Report to Development Permit Panel

DP 09-453125

Application by GBL Architects Ltd. for a General Compliance at 9388 Odlin

Road (former 9340, 9360 and 9400 Odlin Road)

Attachment 2: Changes to Approved Development Permit Elevations.

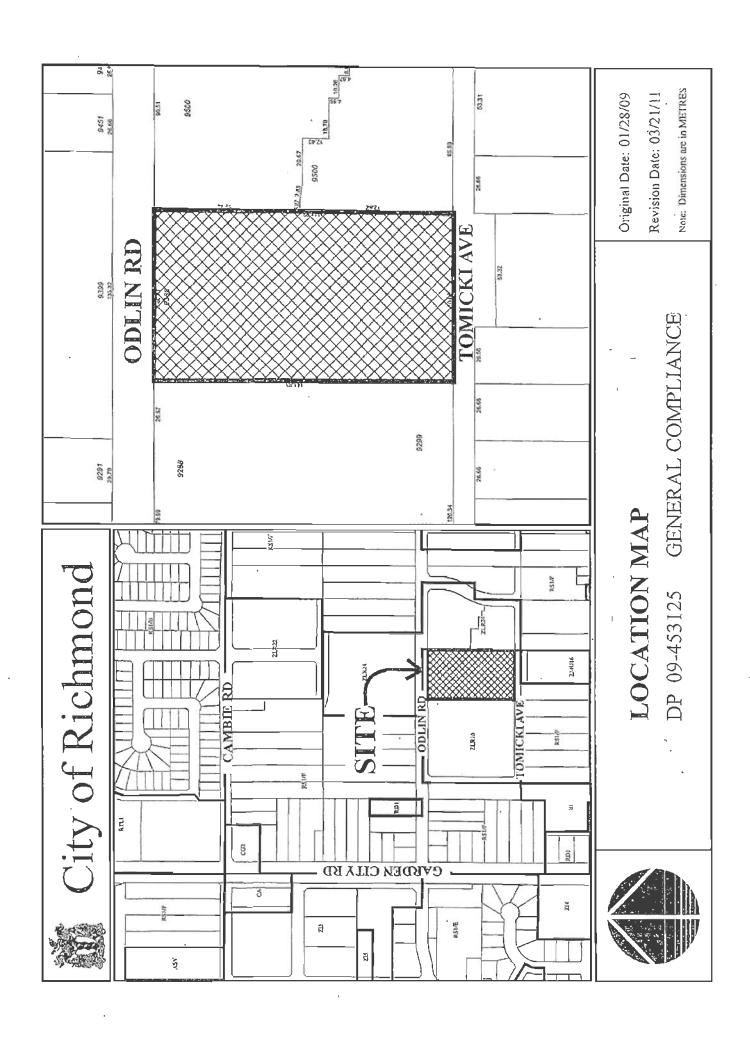
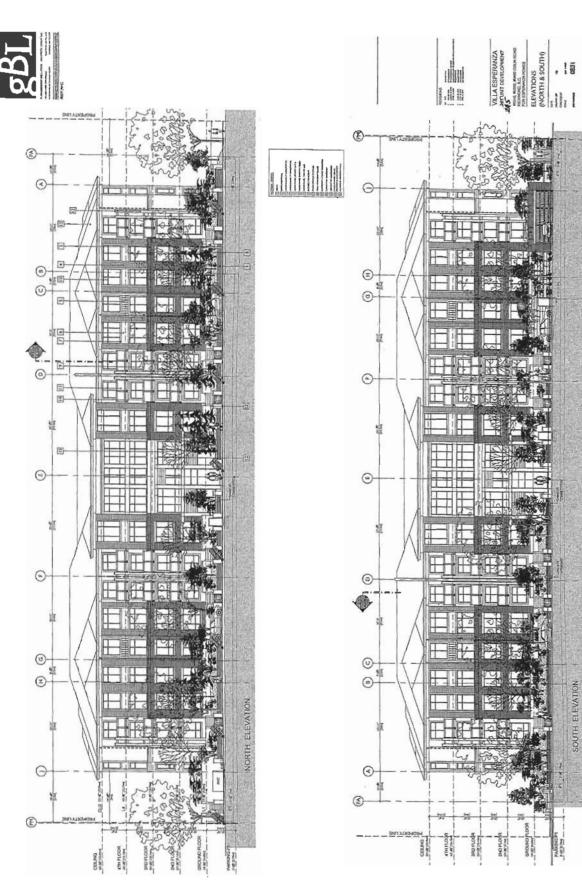
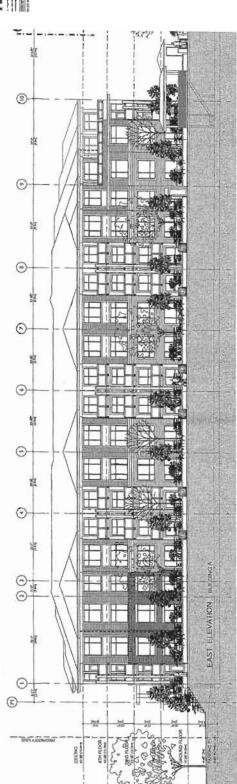
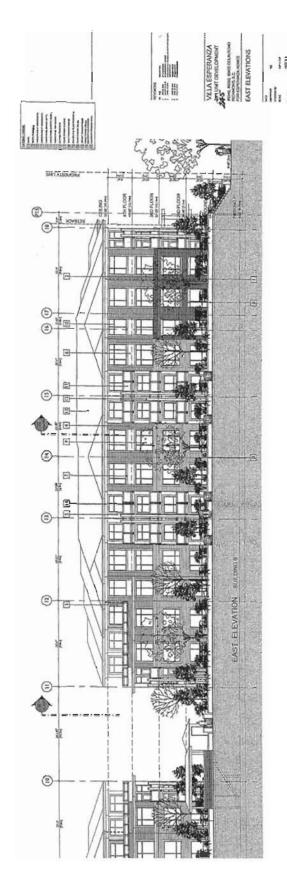
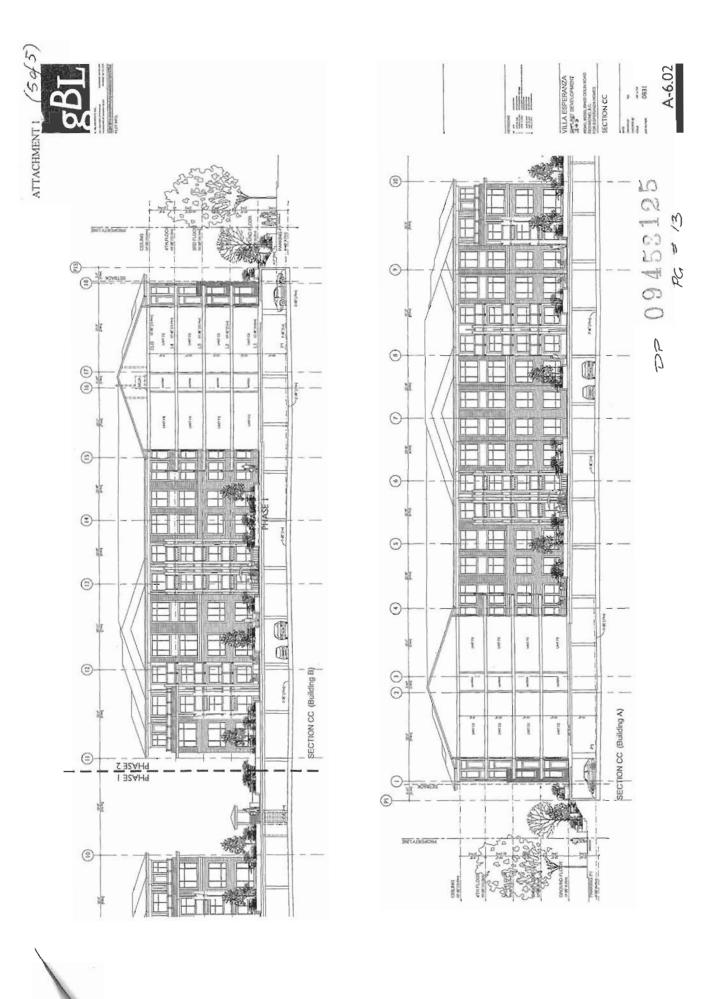
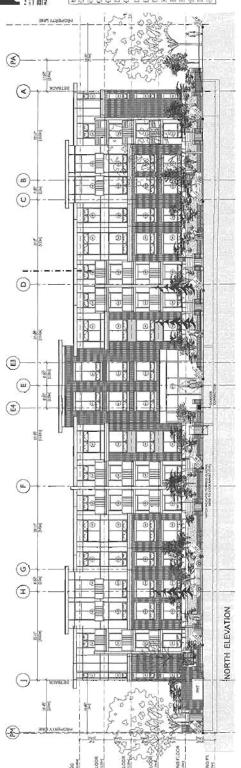
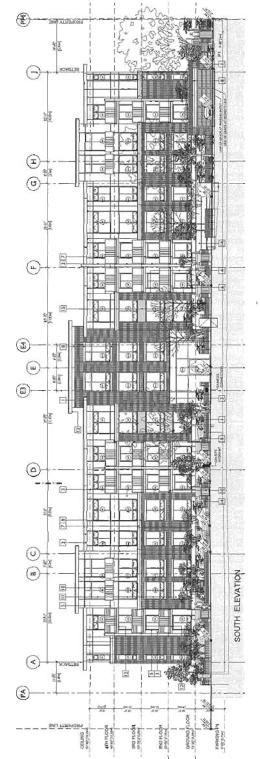
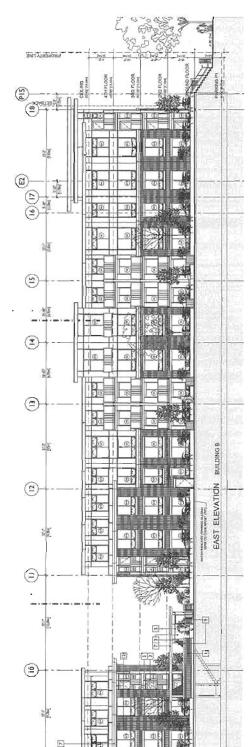
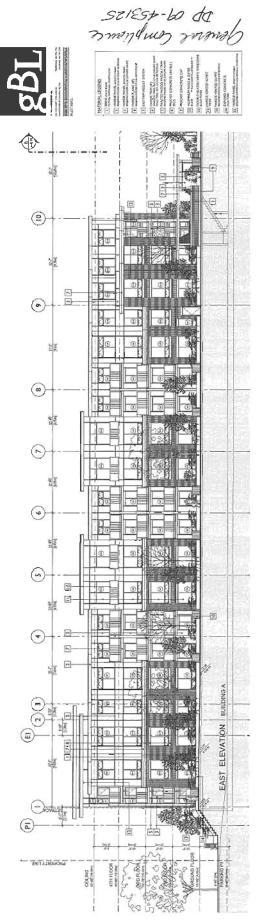
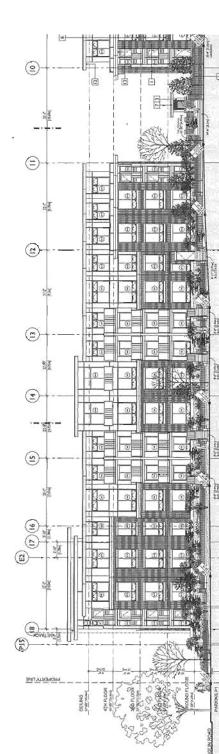
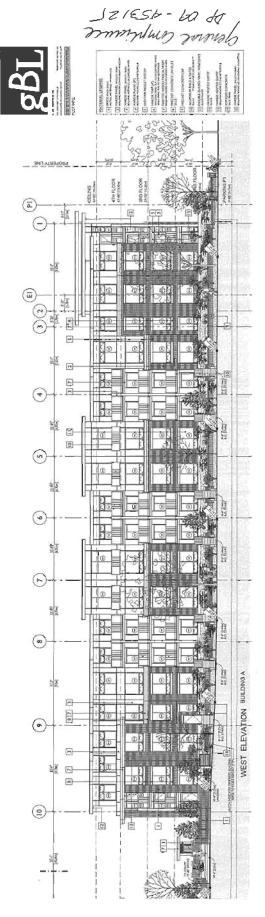
- Changing the original roof from a shallow slope hip roof form to a flat roof.
- Breaking the continuous line of the fascia and soffit with slightly higher portions of the building, capped with a flat roof and visor extensions.
- Changing the extent and distribution of brick use on building facades (limited to the lower two floors and at a constant height) in the approved Development Permit.
- Introducing strong cornices and reinforcing horizontal lines on building facades.
- Achieving cleaner lines and expressing windows vertically.
- Introducing smooth finish Hardie panels and Easy Trim reglet system as a soft contrast background to the richer texture of the brick, which is proposed to be more dominant in the building elevations.

- Changes to the roof lines and strategic use of brick, in contrast with the proposed Hardie
 panel and Easy Trim reglet system, simplify and achieve a good articulation of façades that
 add to a playful expression of the building(s).
- The proposed reglet system that contains, and more accurately defines the proposed Hardie panel edges, allows for crisper lines that help reinforce the desirable vertical expression of the windows.
- Changes to the original hip roof form and lines are not noticeable at street level, as both the original low slope hip roof and the revised flat roof being proposed present a flat soffit to views from the street.

- The changes in height of the flat roof design being proposed reinforce the building mass articulation and accentuate its horizontal lines. The addition of stronger cornices that cap the height of the brick accents also contributes to achieving this objective.
- More extensive use of brick accentuate the mass of the corners of the building(s) at both ends of Alexandra Way pedestrian corridor, anchoring and visually identifying the entrances to this public pedestrian corridor at Odlin Road and Tomicki Avenue. This same treatment is also being introduced at the end corner of the buildings that frame the entry area to the interior courtyard from Alexandra Way.
- More extensive use of brick and vertical articulation of flat roof is also used to identify the building(s) front entry and provide interest to the street fronting building facades.

That the attached plans involving changes to the building elevations be considered in General Compliance with Development Permit (DP 09-453125).
